PARE MARK-UP
2024-02-14
NOT FOR CONSTRUCTION

Project
NORTHBOROUGH FIRE STATION
63 WEST MAIN STREET
TOWN OF NORTHBOROUGH, MA

GENERAL PLAN

Drawing Title
BATTERWALL

C-300

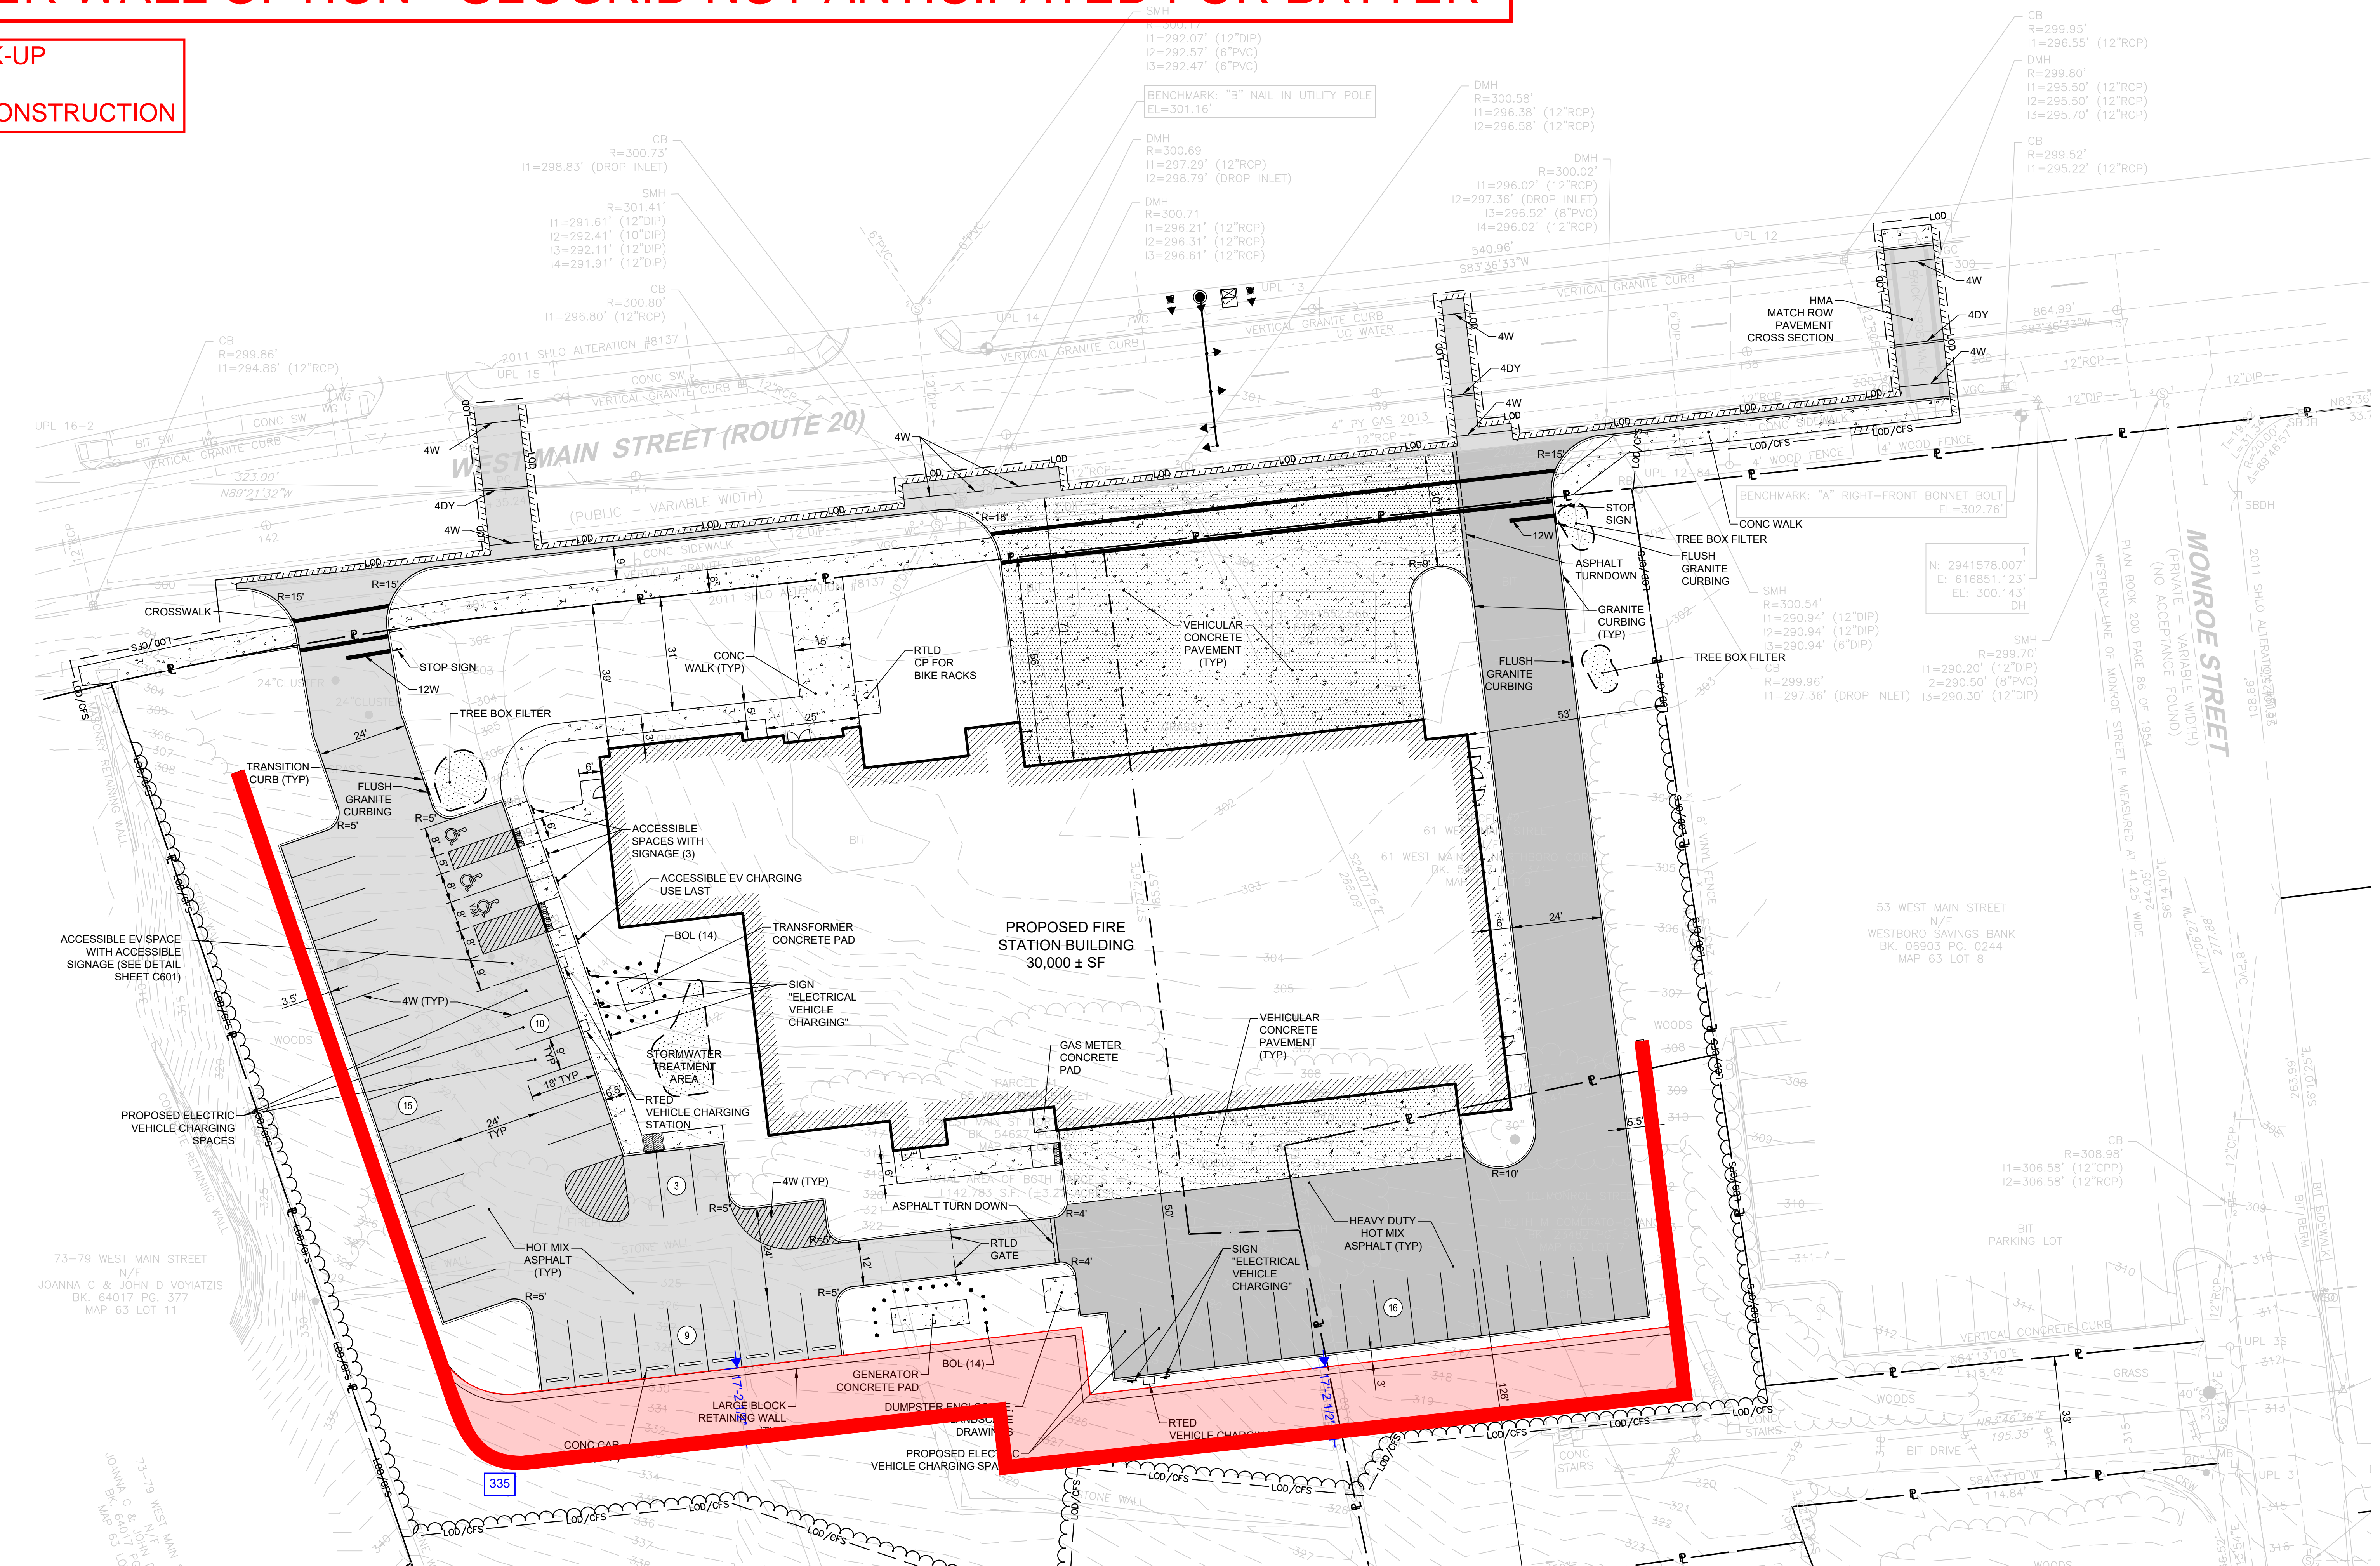
BATTER WALL OPTION - GEOGRID NOT ANTICIPATED FOR BATTER OPTION 2

Drawing number
C-300

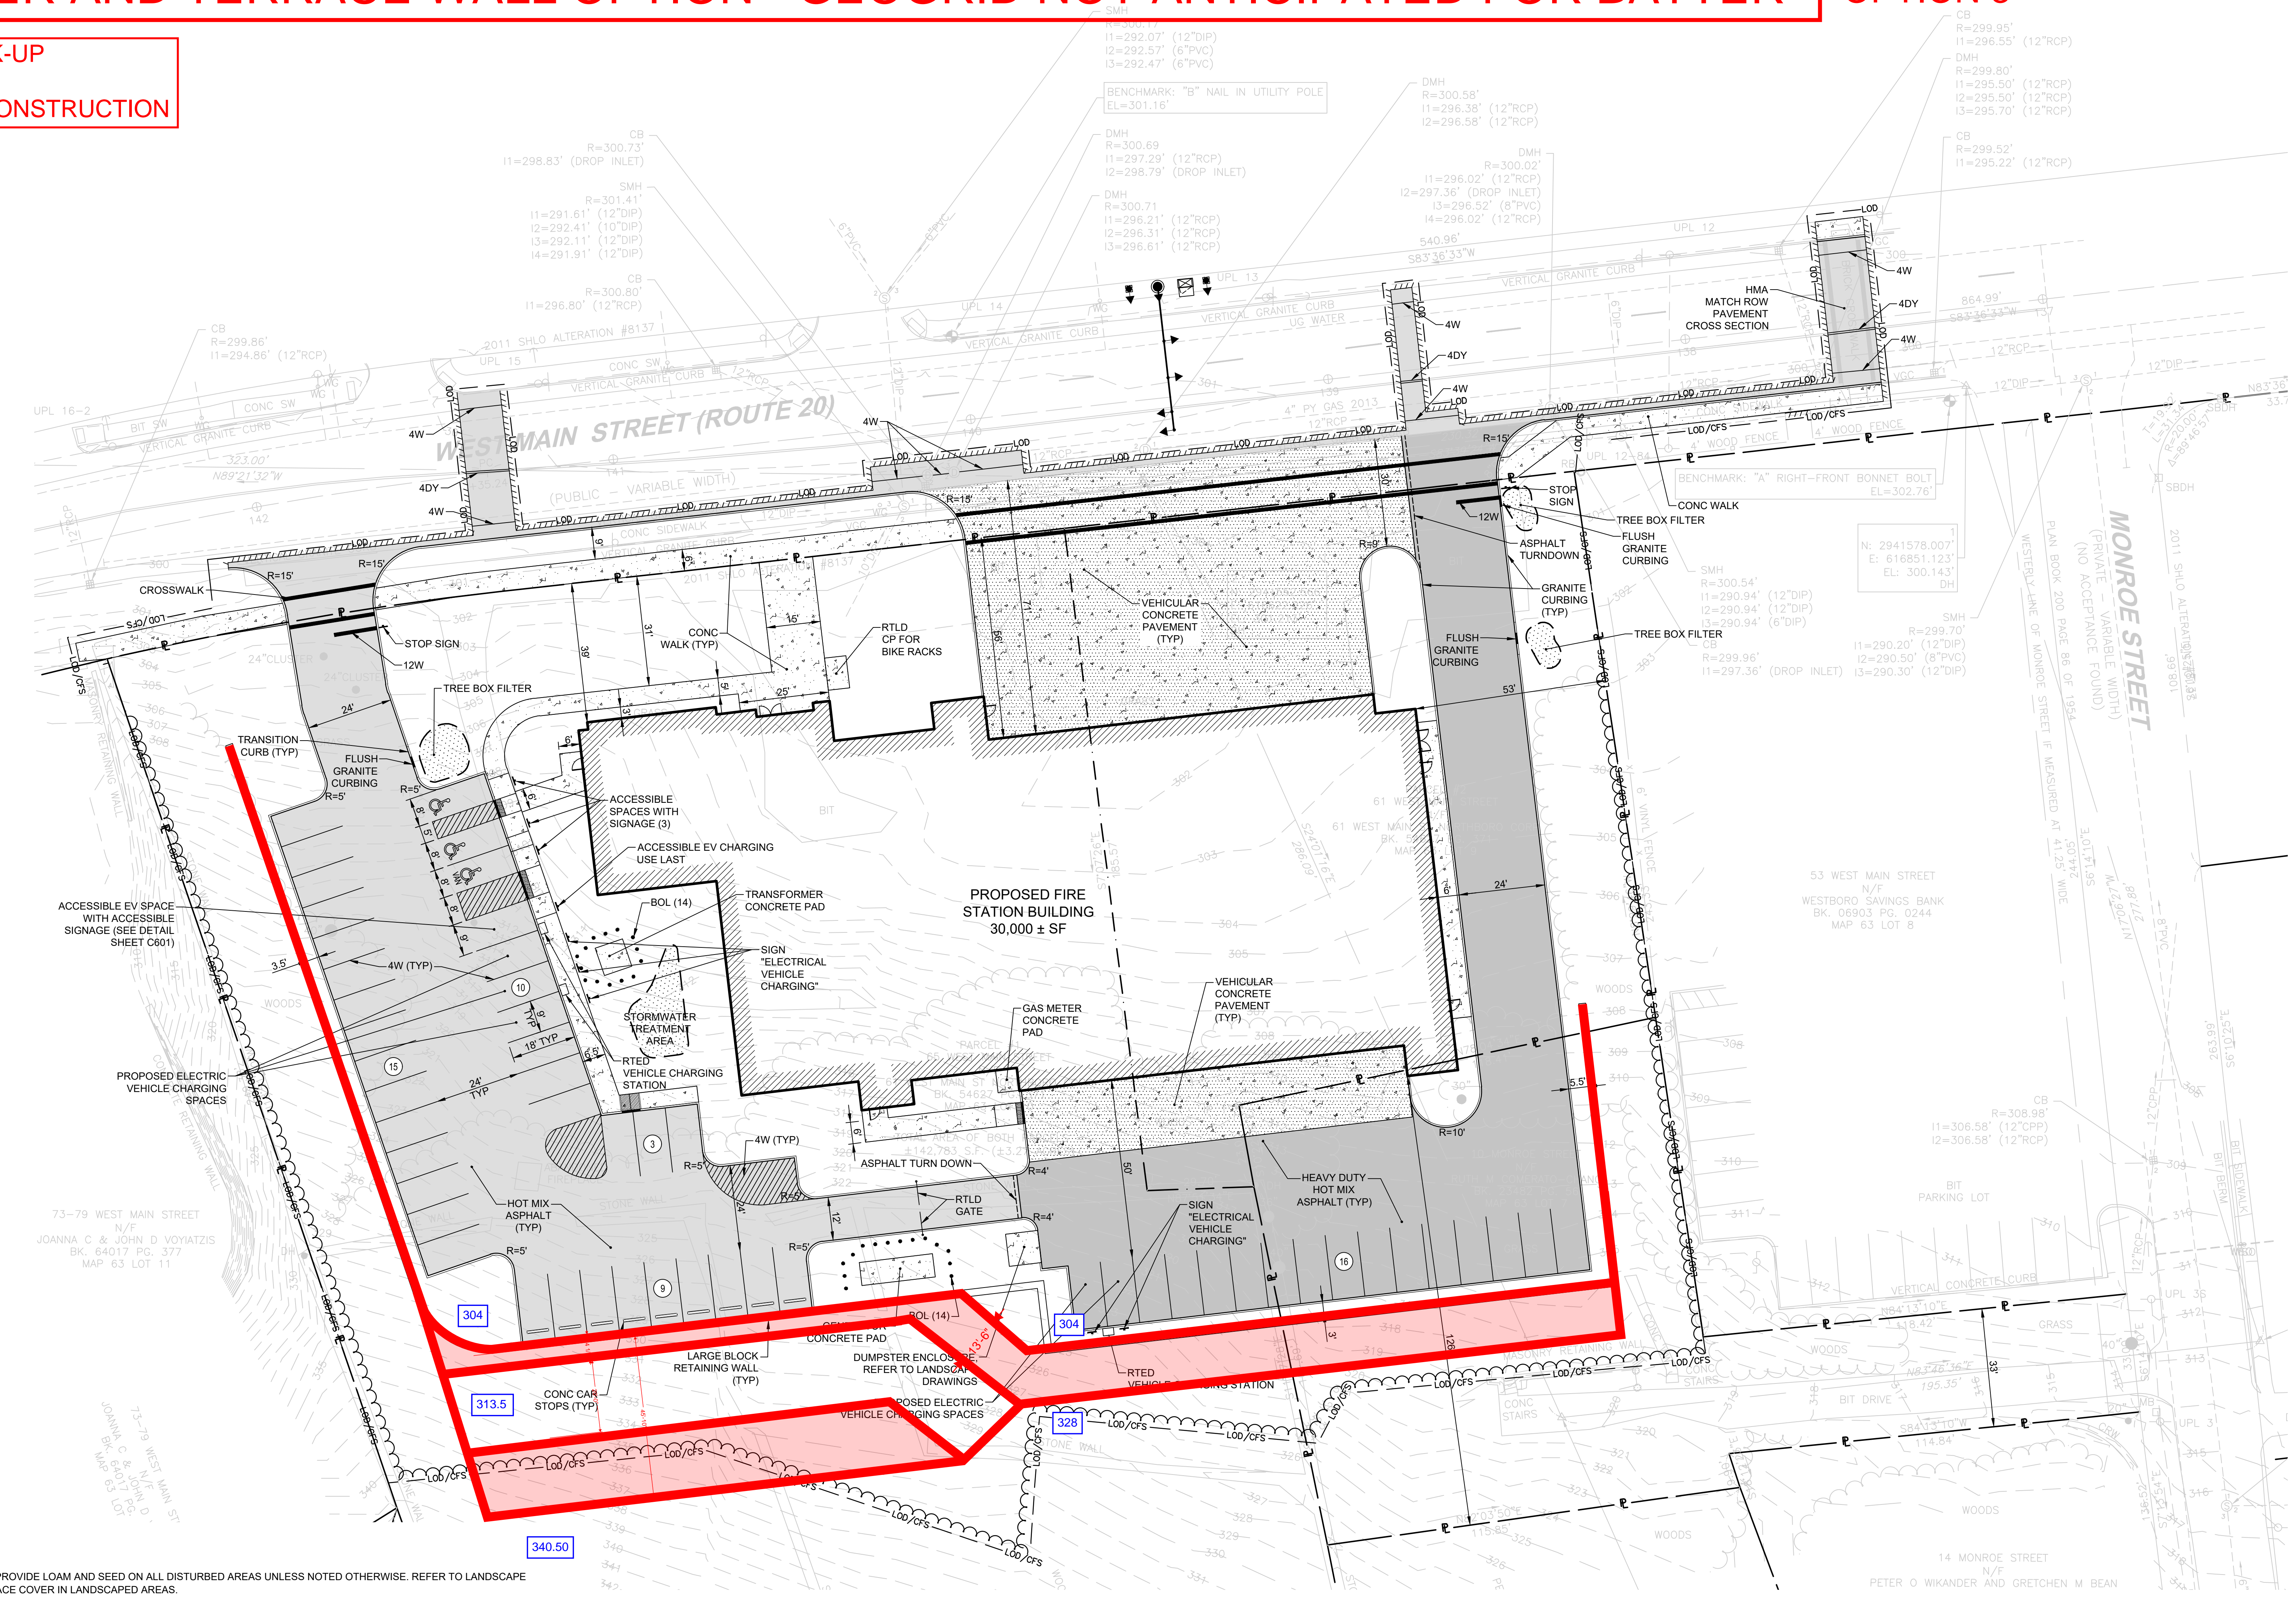
BATTER AND TERRACE WALL OPTION - GEOGRID NOT ANTICIPATED FOR BATTER OPTION 3

Drawing number
C-300

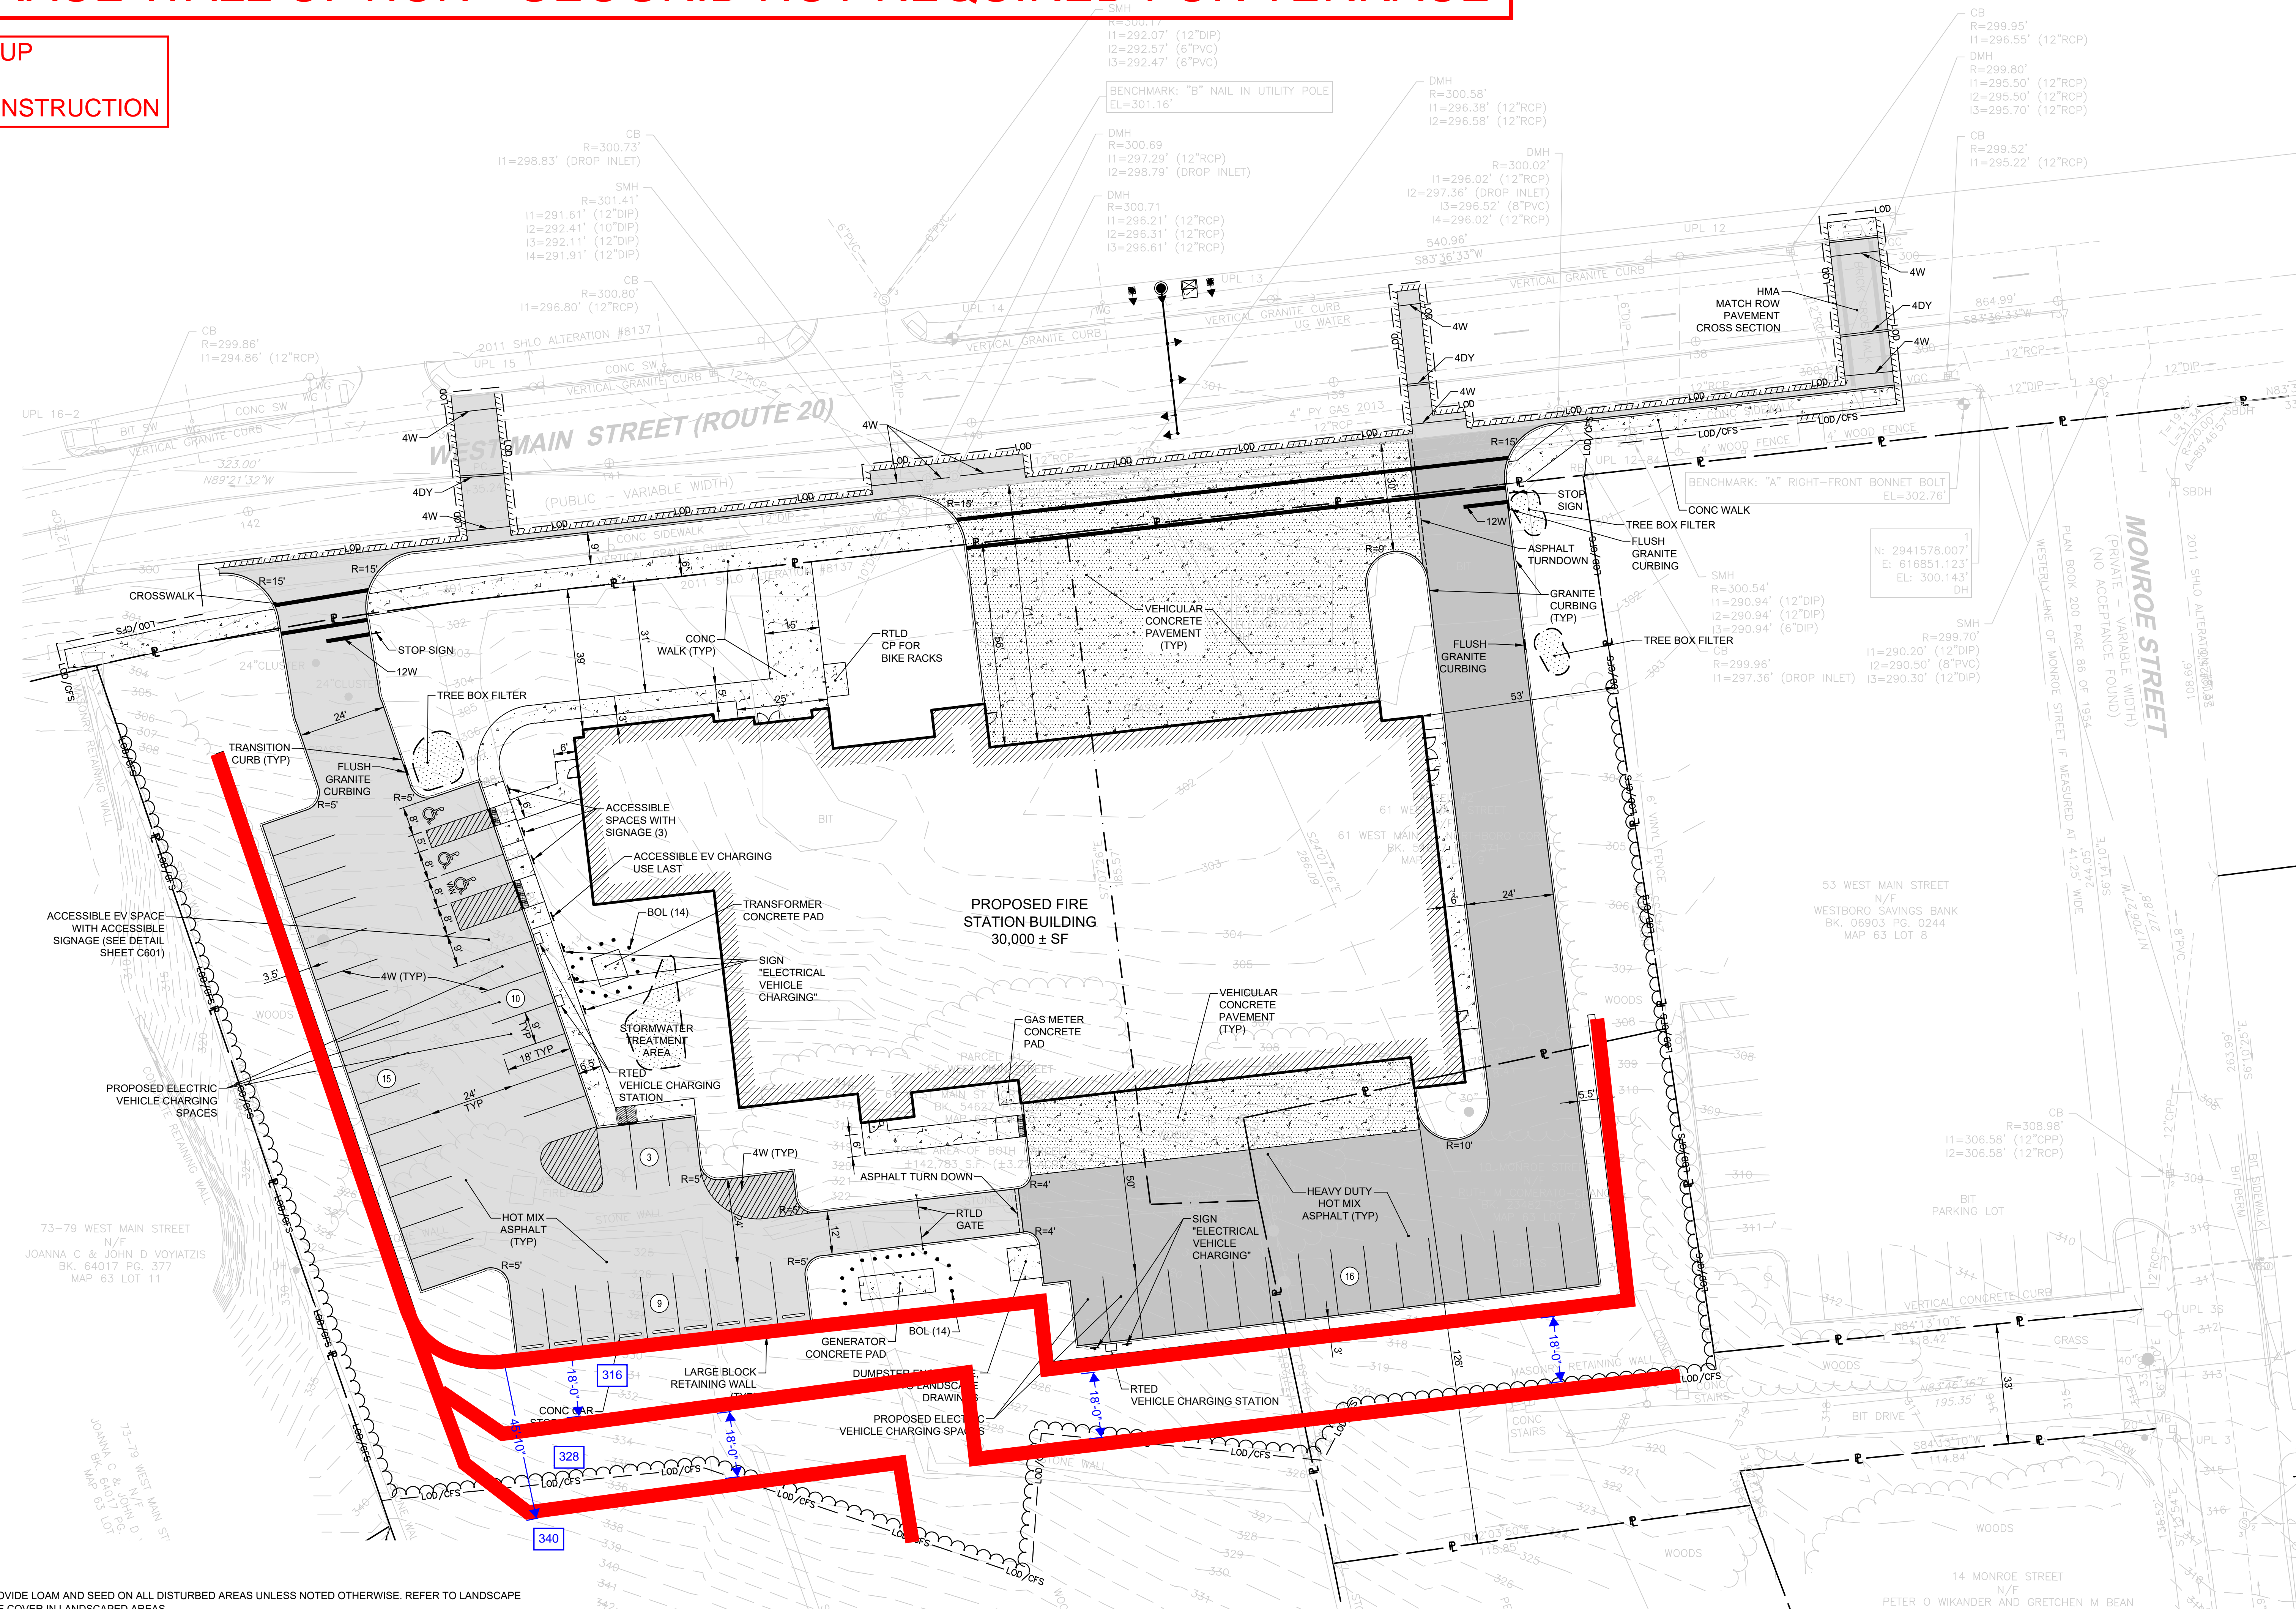
2 TERRACE WALL OPTION - GEOGRID NOT REQUIRED FOR TERRACE OPTION 5
